**FINAL DRAINAGE REPORT FOR
HOMESTEAD AT STERLING RANCH
FILING NO. 2**

Project #09-007
SF -19-004

Engineering Review

**EPC Planning & Community
Development Department**

EDB AND SFB DETAILS

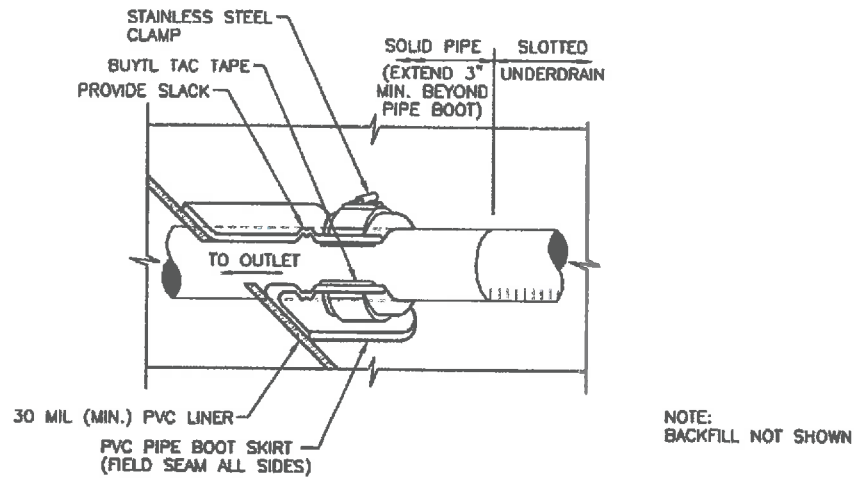
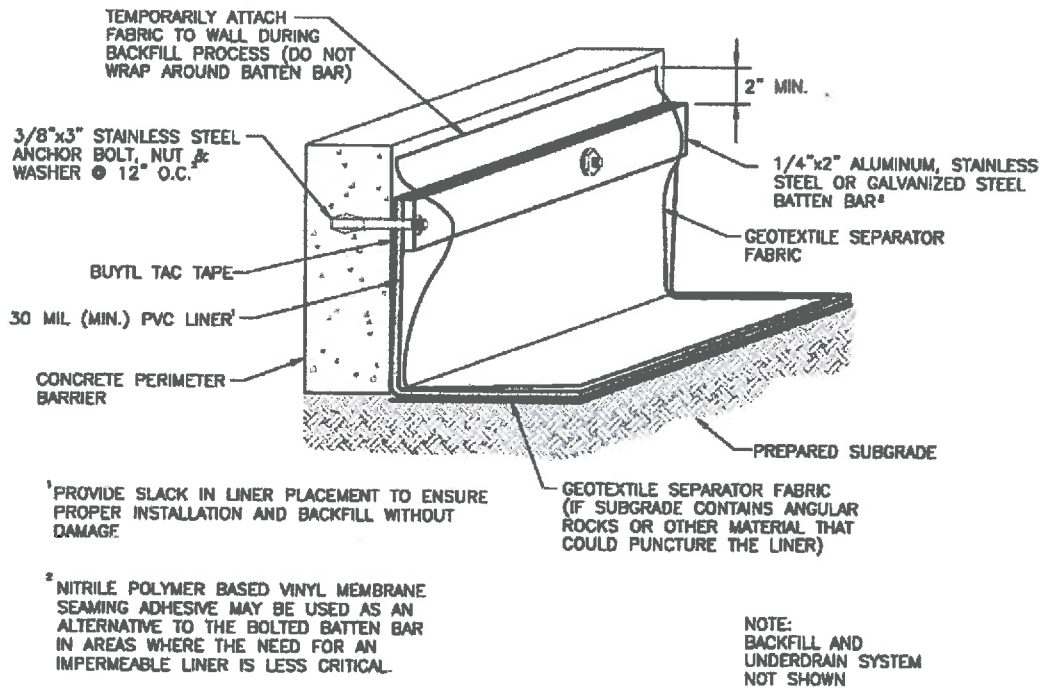
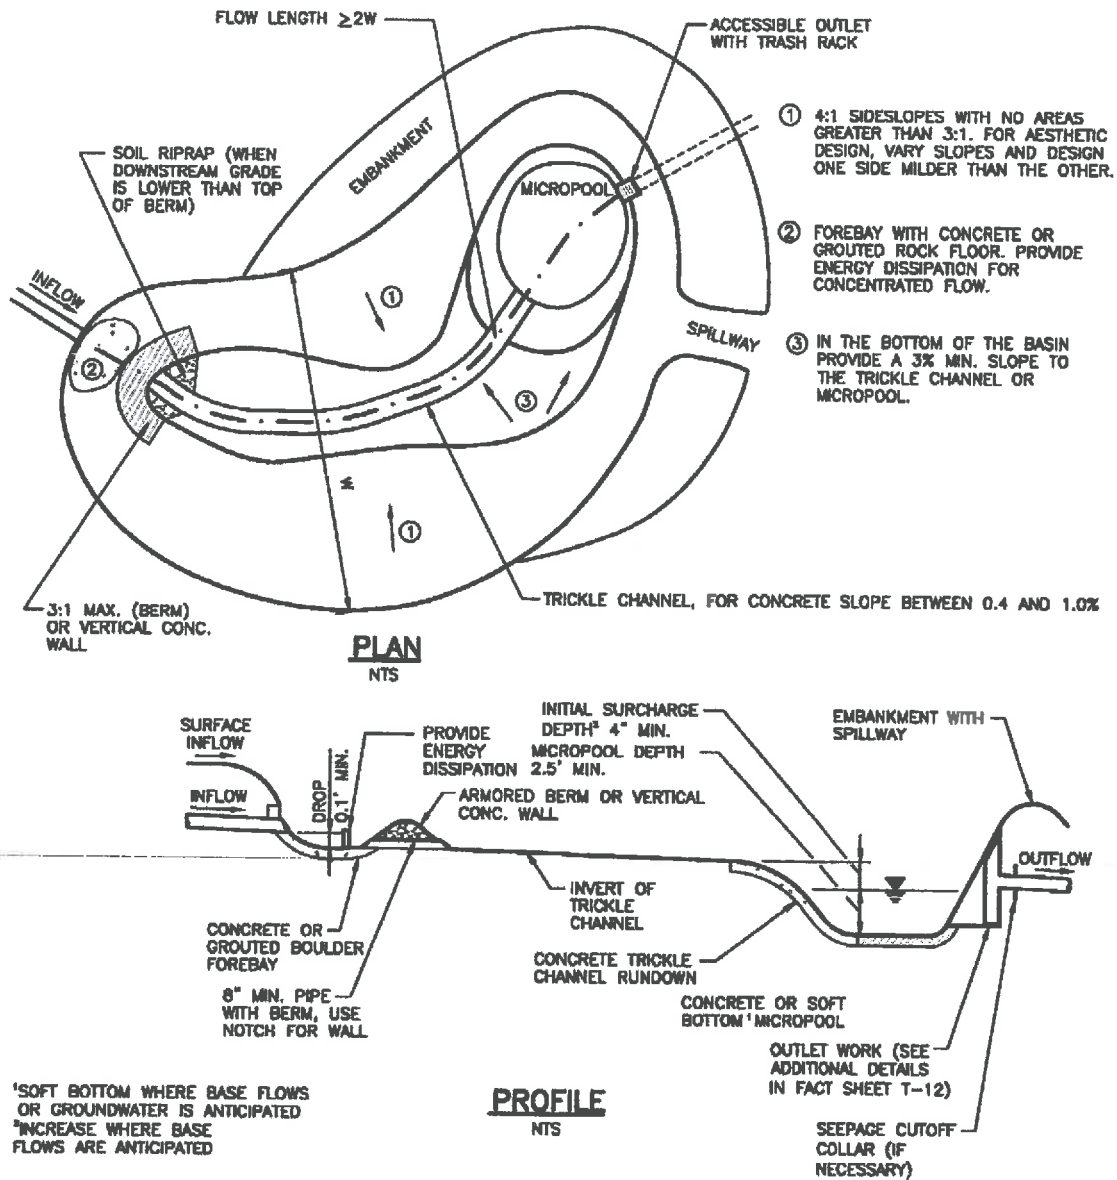
Add a more specific detail for the 52 SFB's that will be used for backyard WQCV. Since all 52 will be similar, provide the outlet structure detail, the outfall pipe sizing information, Fencing, (Split rail fence), etc.

And drainage and access easement.

HOMESTEAD AT STERLING RANCH FIL. NO. 2			
PROPOSED DRAINAGE MAP			
PROJECT NO. 09-007	SCALE: HORIZONTAL: 1"=100'	DATE: 01/15/2020	PDM
DESIGNED BY: CMN	CHECKED BY: VAS	SHEET 1 OF 1

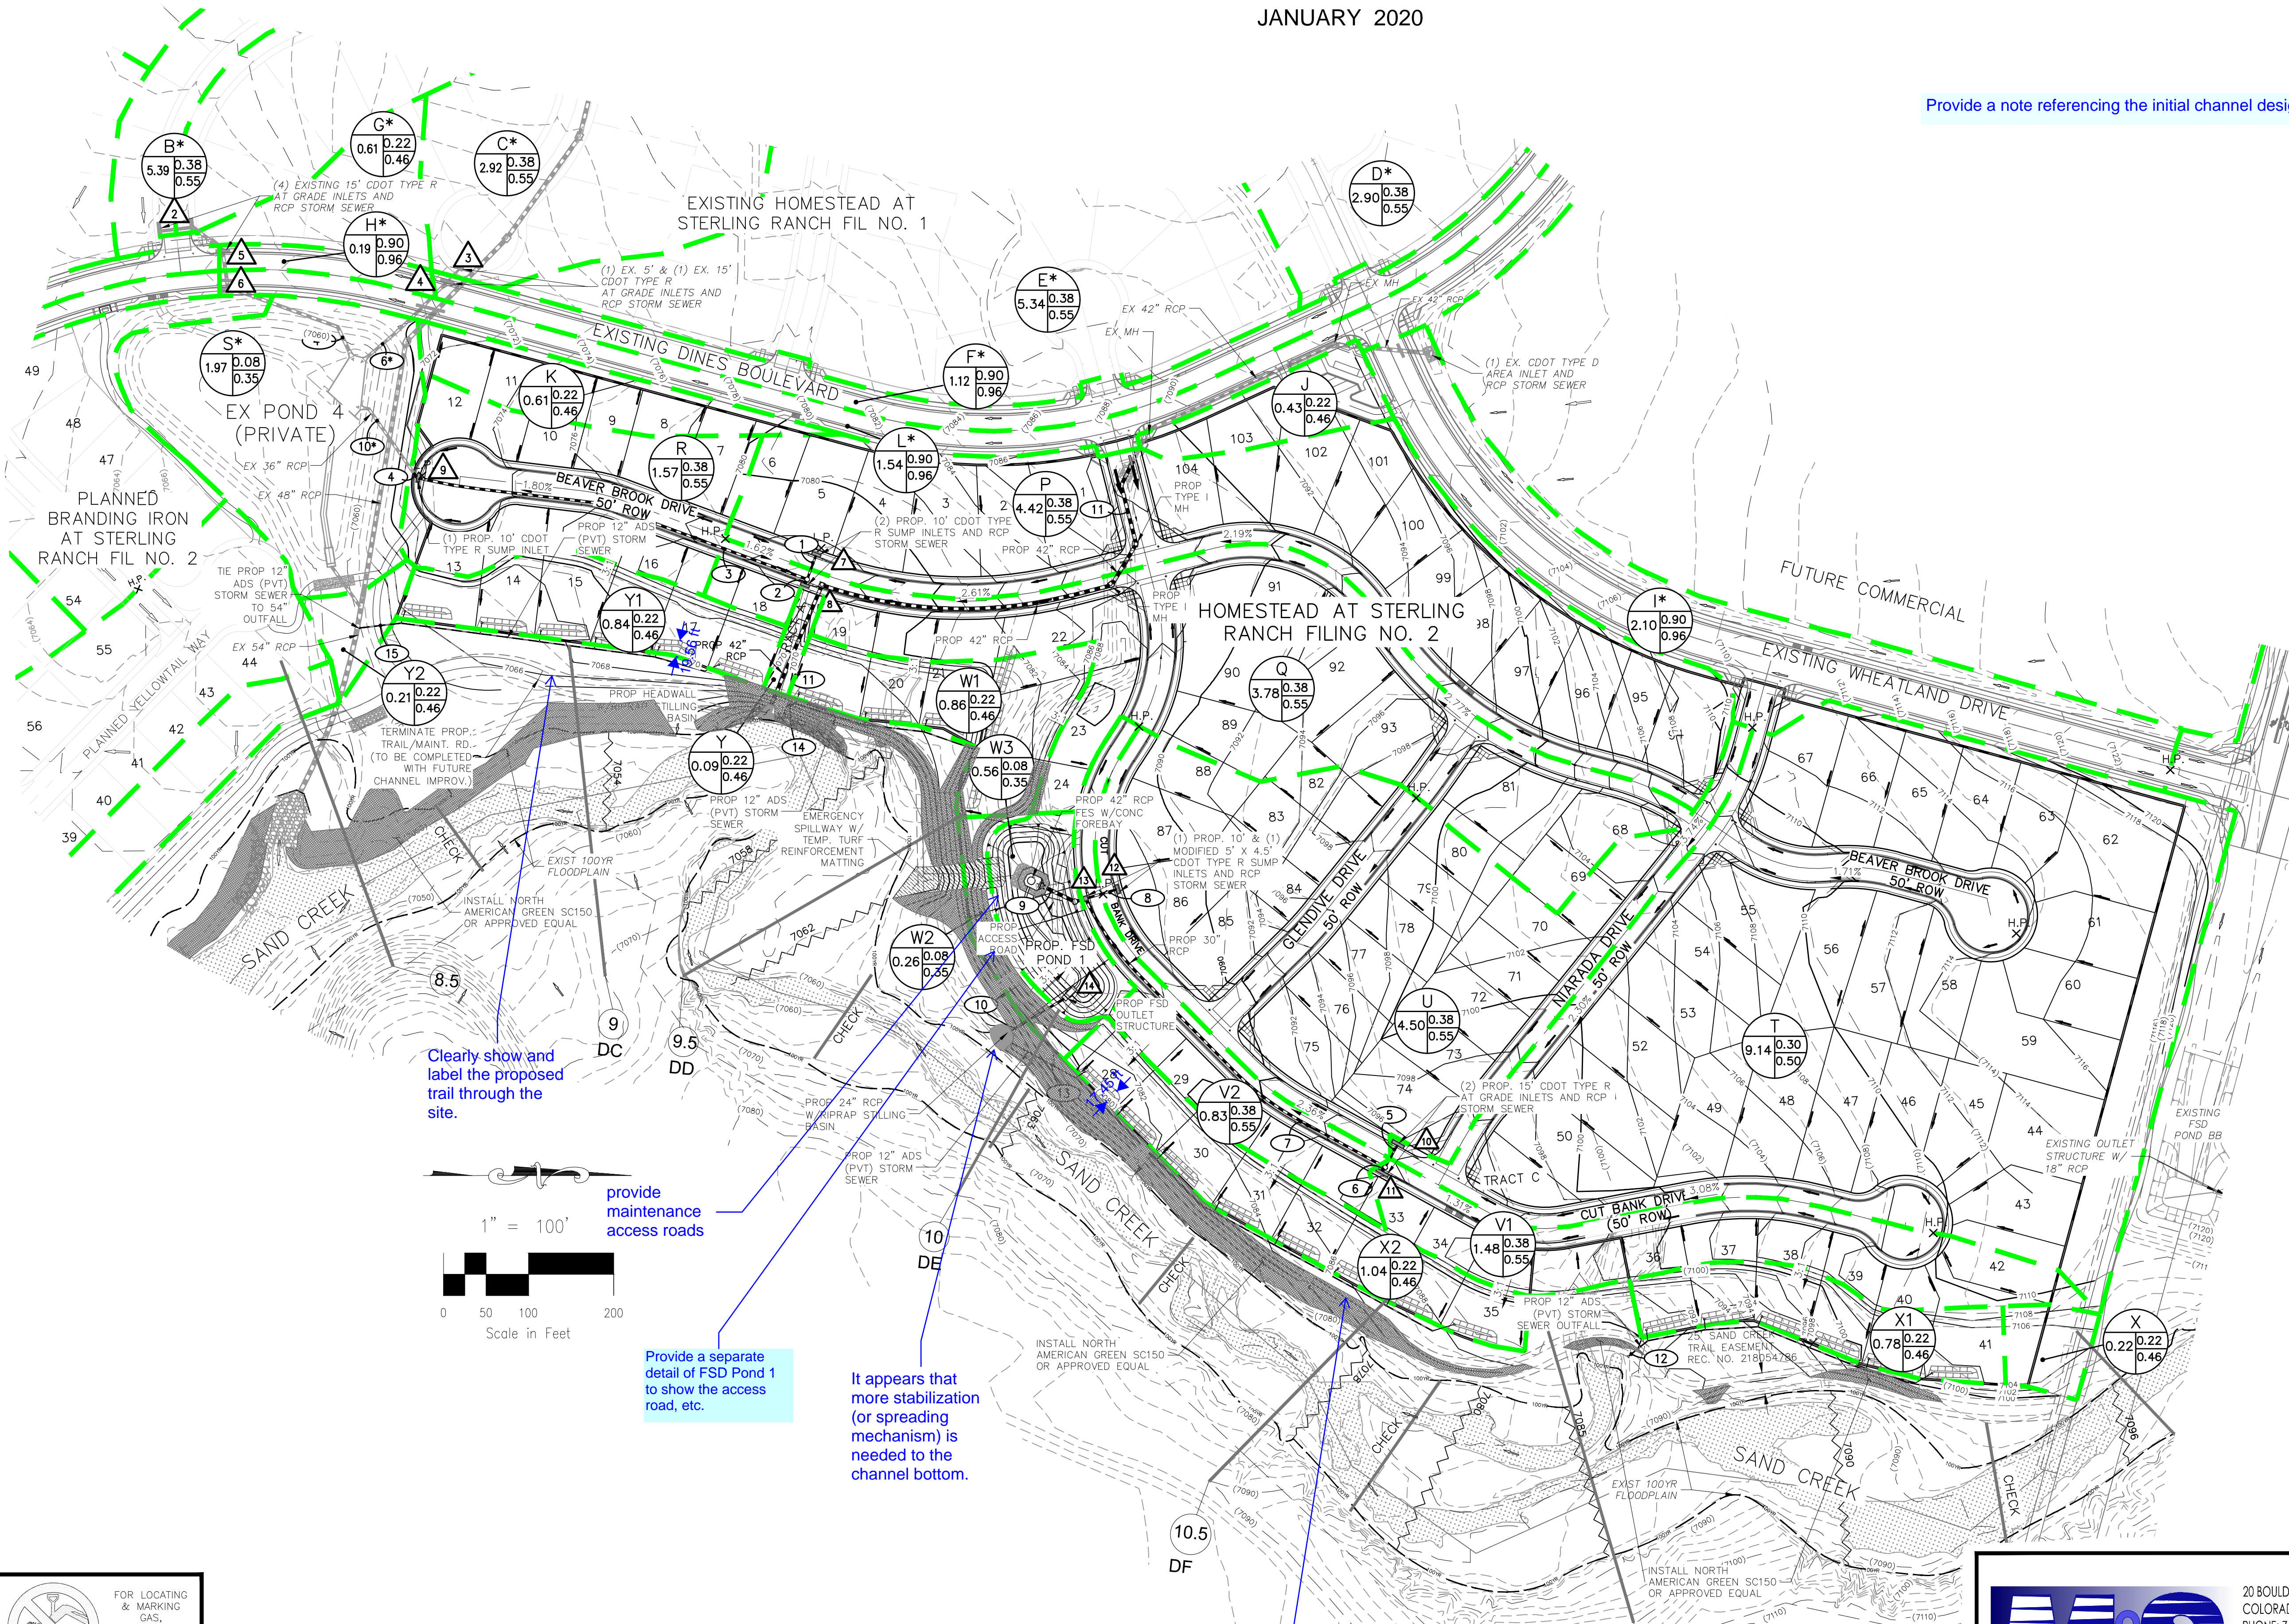
Provide a note referencing the initial channel design plans.

Clearly show and label the proposed trail through the site.

provide maintenance access roads

Provide a separate detail of FSD Pond 1 to show the access road, etc.
